HISTORIC AND DESIGN REVIEW COMMISSION

HDRC CASE NO: 2021-380
ADDRESS: 232 LAVACA ST
LEGAL DESCRIPTION: NCB 713 BLK 10 LOT 16 & E 4 FT OF 15
ZONING: RM-4,H
CITY COUNCIL DIST.: 1
DISTRICT: Lavaca Historic District
APPLICANT: Clint Belew/BelewHouse
TYPE OF WORK: Exterior modifications, construction of a 2-story rear addition
APPLICATION RECEIVED: November 09, 2021
60-DAY REVIEW: Not applicable due to City Council Emergency Orders
CASE MANAGER: Stephanie Phillips

1. Remove the non-original 2-story rear addition.
2. Construct a new 2-story rear addition.
3. Replace the existing non-original front porch columns with round columns.

PROPOSED 4'-0" FENCE EXAMPLE

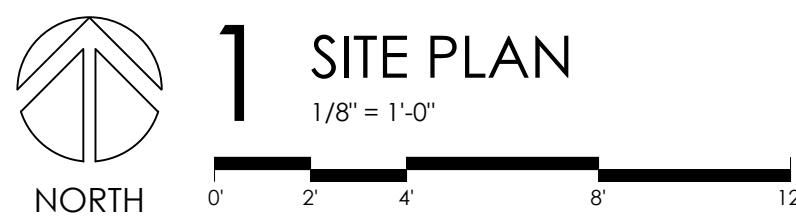
- p. **FENCING** – The submitted renderings include new cattle panel style fencing. The requested fencing in the front yard is proposed to be 4'-0" in height and fully metal, including the hogwire and vertical and horizontal fence components. According to the Historic Design Guidelines, new front yard fences should appear similar to those used historically within the district in terms of their scale, transparency, materiality, and character. Staff finds that cattle panel fencing is generally appropriate for the district, but finds that the posts and rails should be wood in lieu of the proposed fully metal fence, which is more consistent with fence materials historically used in the Lavaca Historic District.

- viii. That the posts and rails on the proposed fencing be wood in lieu of the requested fully metal fence style as noted in finding p.
- ix. The final construction height of an approved fence may not exceed the maximum height as approved by the HDRC at any portion of the fence. Additionally, all fences must be permitted and meet the development standards outlined in UDC Section 35-514.

SHEET TITLE
Floor Plan
Window Schedule

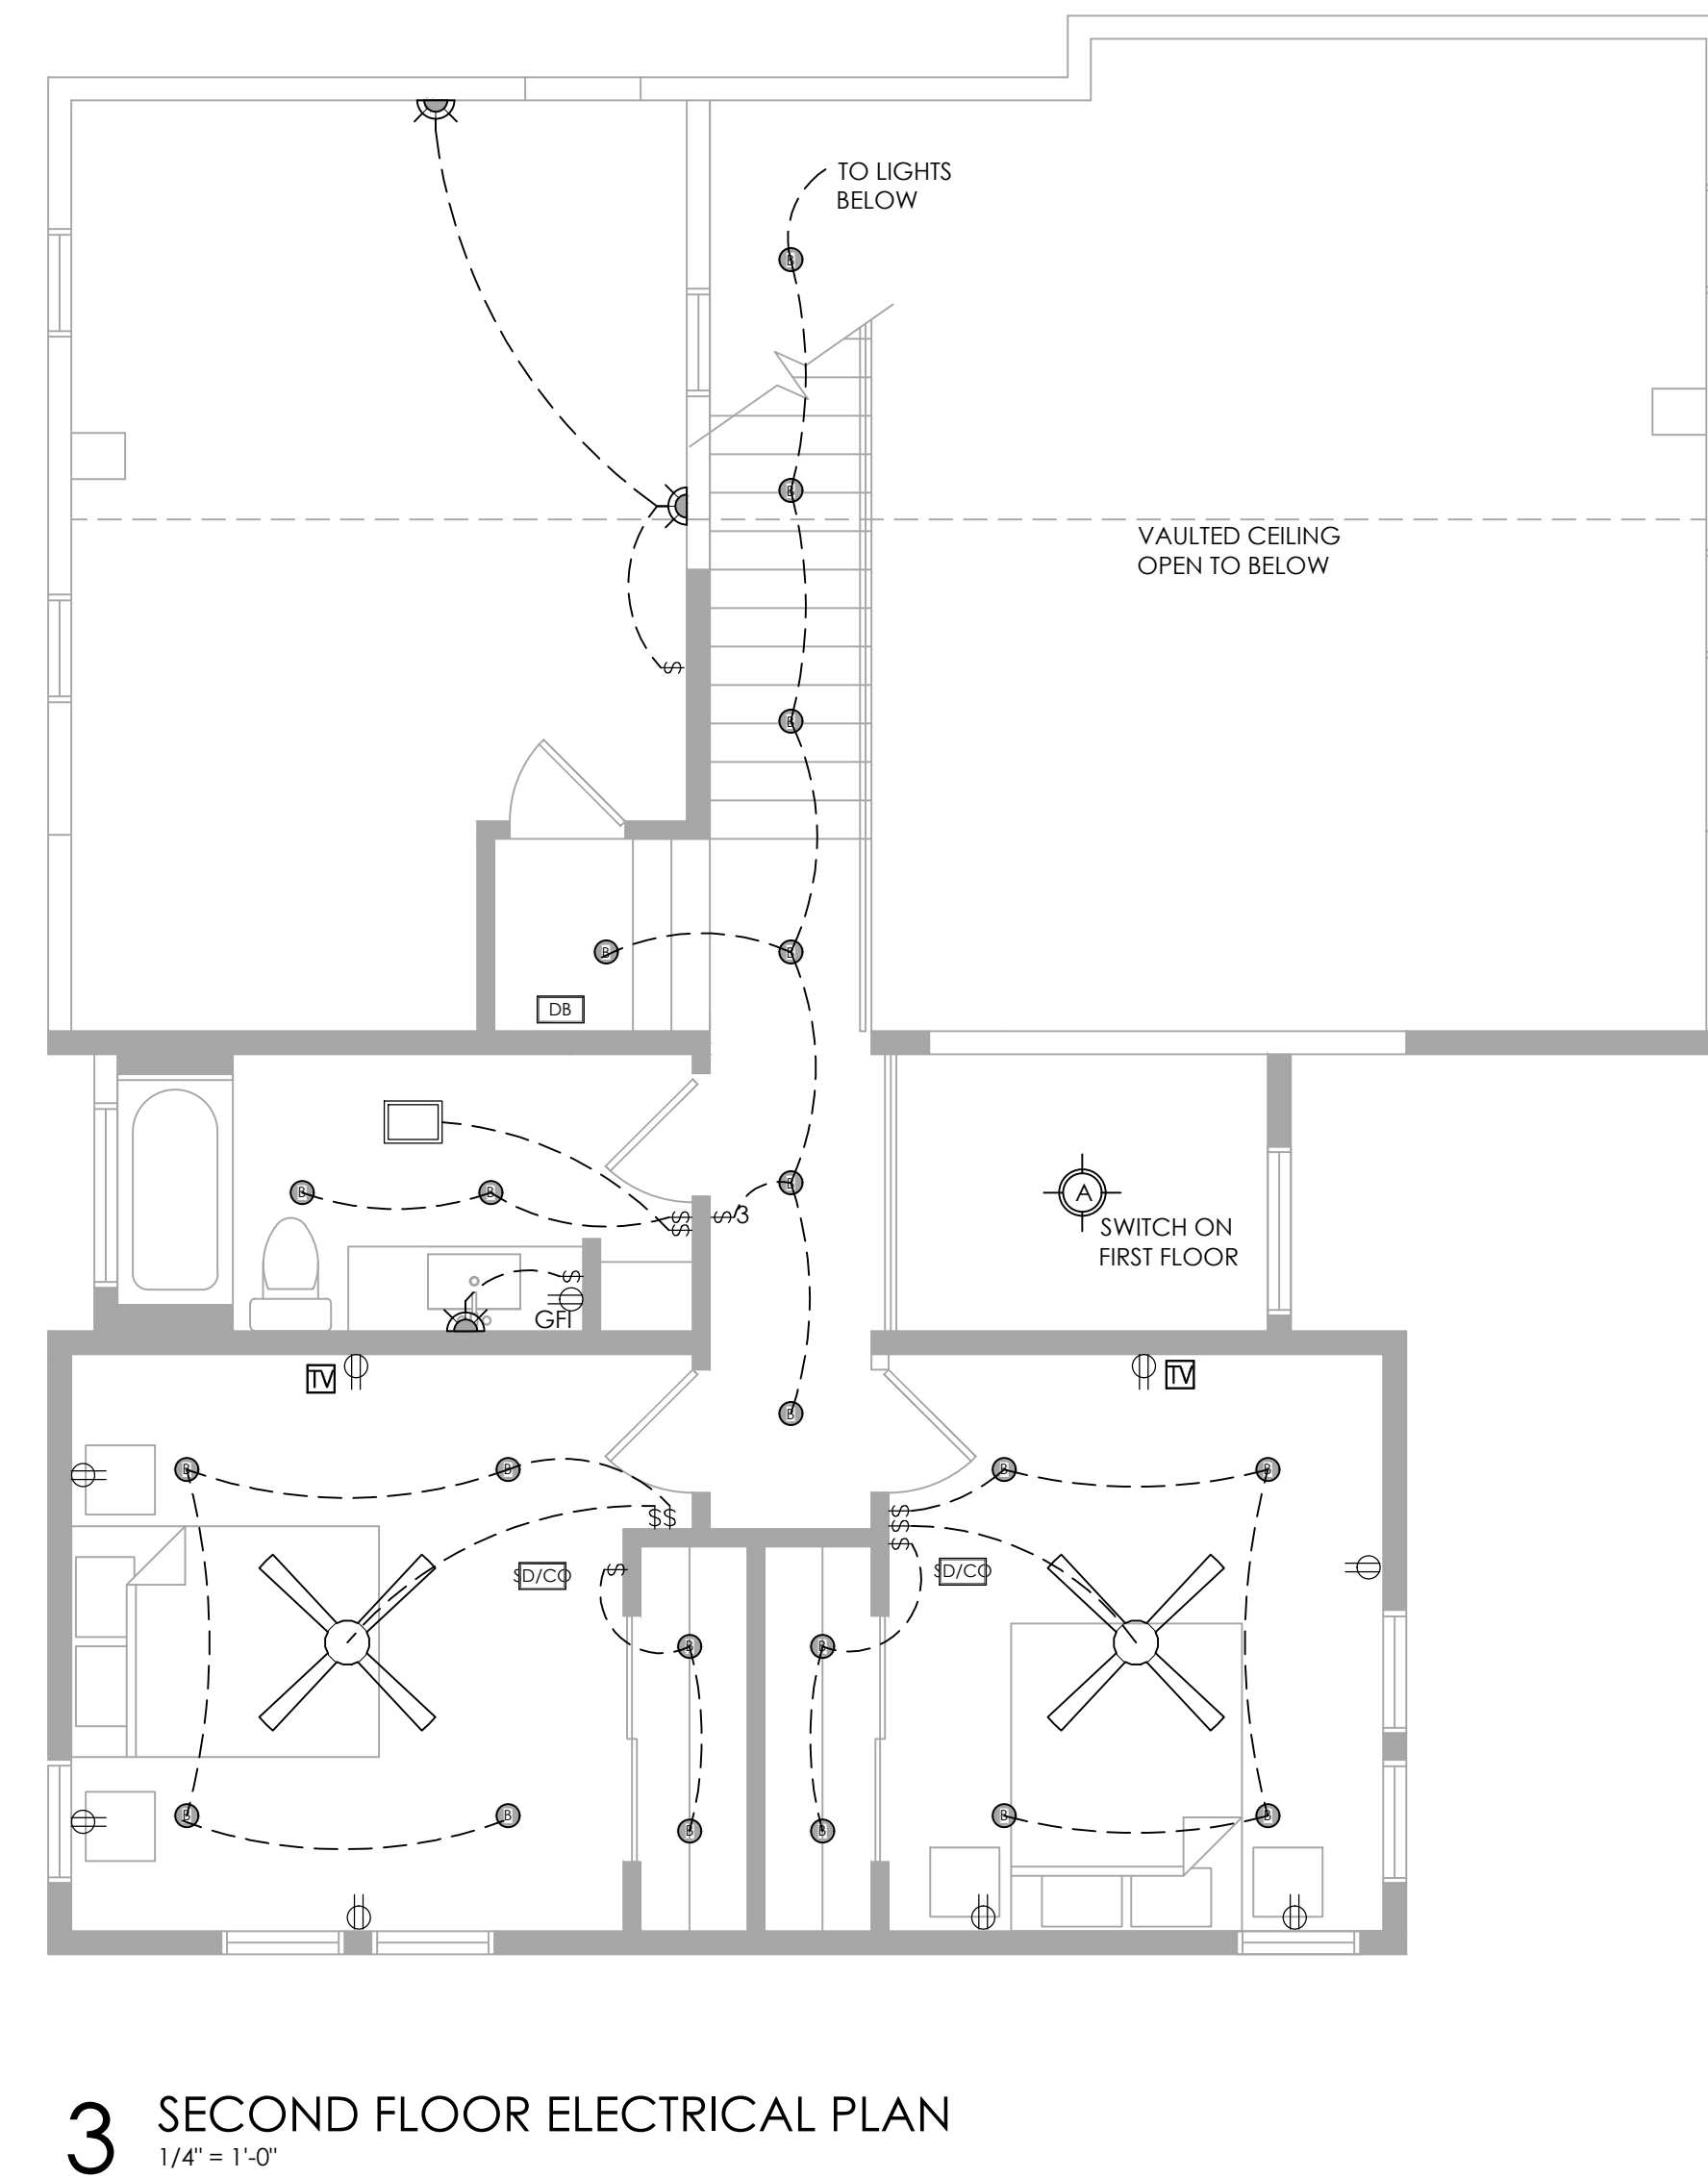
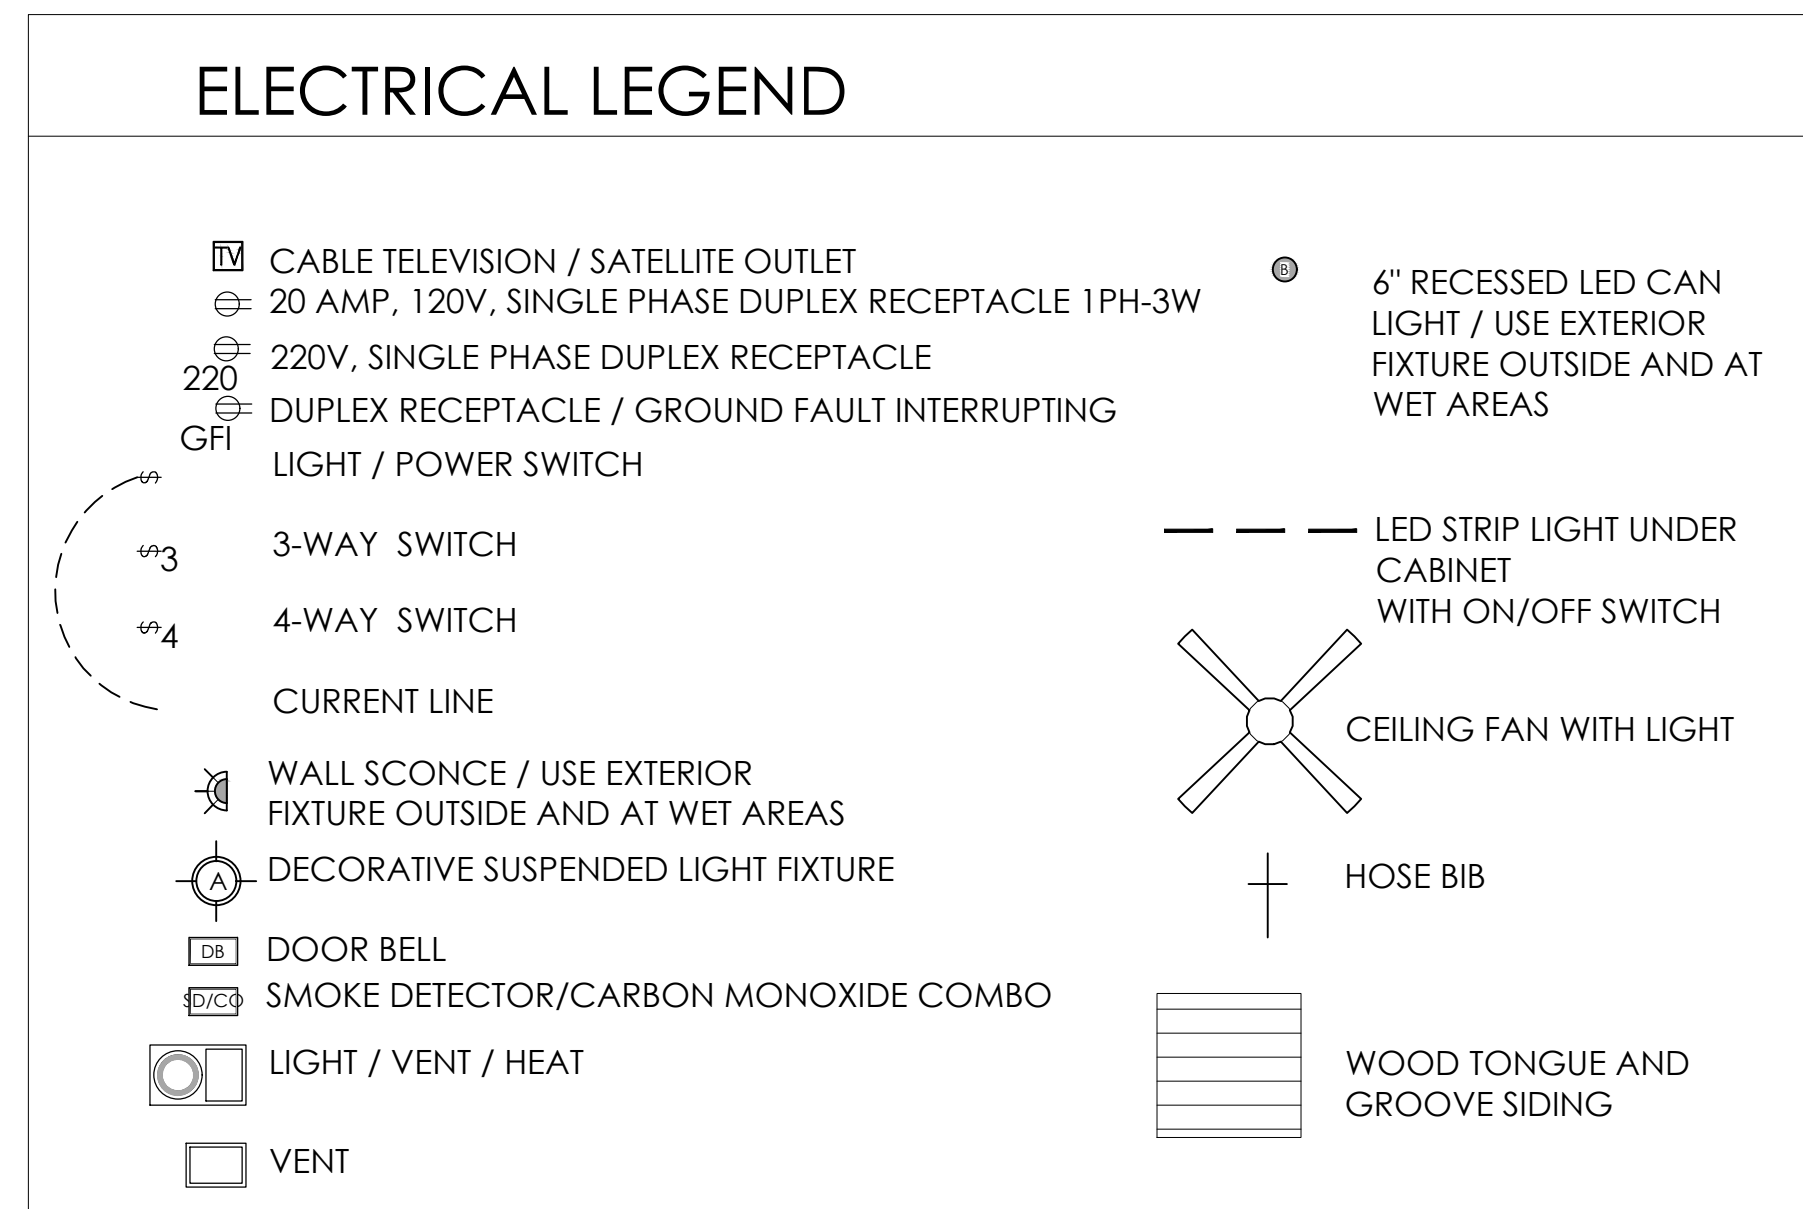
- h. **FENESTRATION** – According to the Historic Design Guidelines, openings in new construction should use traditional dimensions and profiles found on the primary structure or within the historic district. Based on the submitted elevations, the applicant is requesting window sizes and proportions that are a modern interpretation of those found on the primary structure that also incorporate traditional ganged trim conditions, recess, inset, and configurations. Staff finds the proposed fenestration appropriate with the stipulations listed in the recommendation.

- iv. That the applicant submits final window specifications for the addition to staff for review and approval. Windows should be fully wood or aluminum clad wood and feature an inset of two (2) inches within facades and should feature profiles that are found historically within the immediate vicinity. White color is not allowed, and color selection should be presented to staff. Meeting rails must be no taller than 1.25" and stiles no wider than 2.25". There should be a minimum of two inches in depth between the front face of the window trim and the front face of the top window sash. This must be accomplished by recessing the window sufficiently within the opening or with the installation of additional window trim to add thickness. Window trim must feature traditional dimensions and an architecturally appropriate sill detail. Window track components must be painted to match the window trim or be concealed by a wood window screen set within the opening.
